BATEMANS BAY REGIONAL AQUATIC, ARTS AND LEISURE CENTRE

Survey Report – March 2019

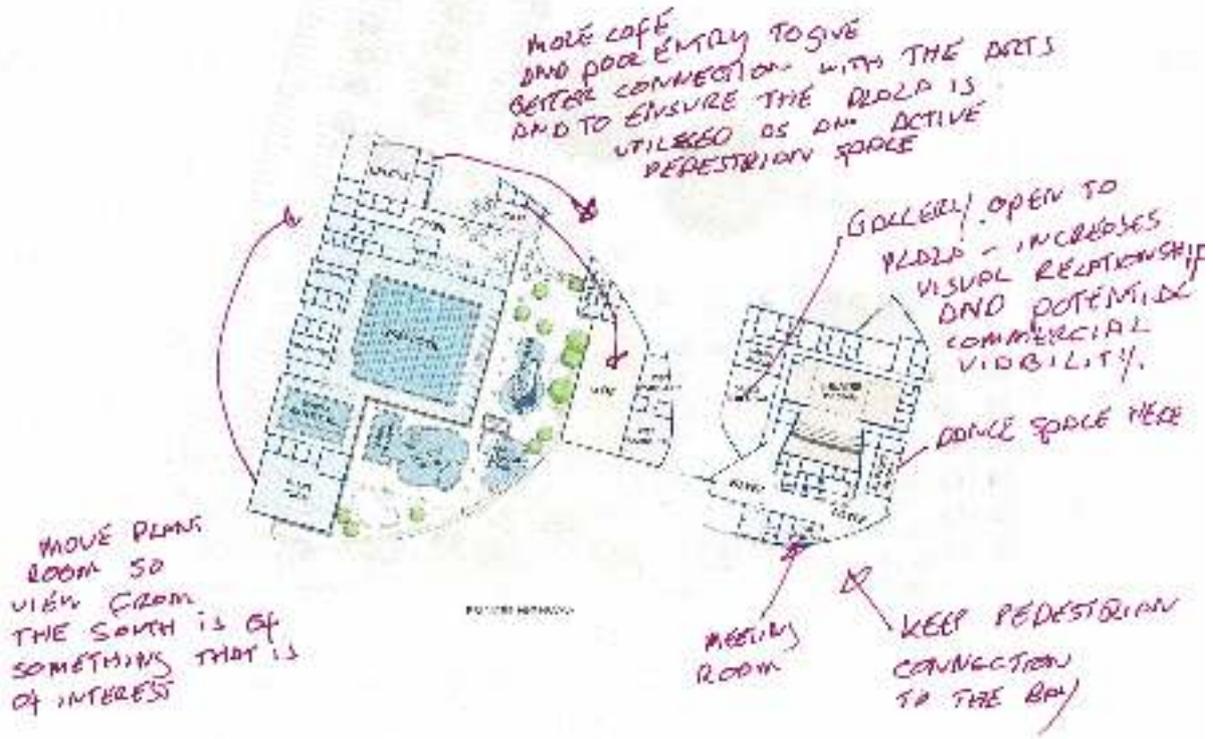
2 Put the gallery where the dance space is and move the dance space to where the meeting room is. This would allow for the arts building to be more visually open to the plaza and again could increase its commerciality.

3 Move the plant room on the pool so that there is a better readability of the building when coming from the south.

4 Ensure the roof terraces have good norther sun and relate to the water views. If you can get great water views to the north this would increase the financial viability of this space- as an events space etc.

CONCEPT A FIRST FLOOR

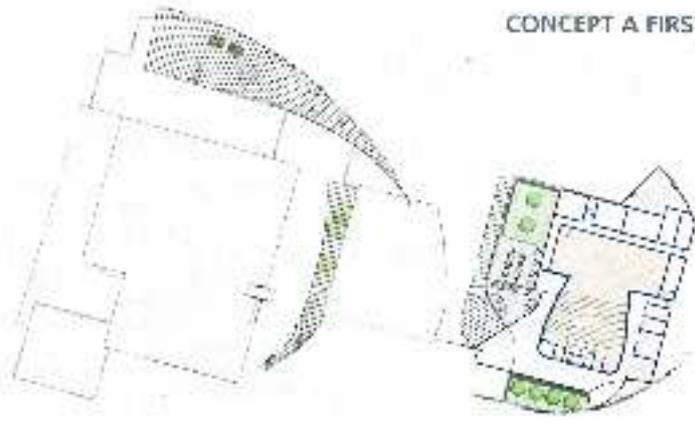
ROOF TERRACE FACE NORTH FOR SUN + VIEW OF RIVER.
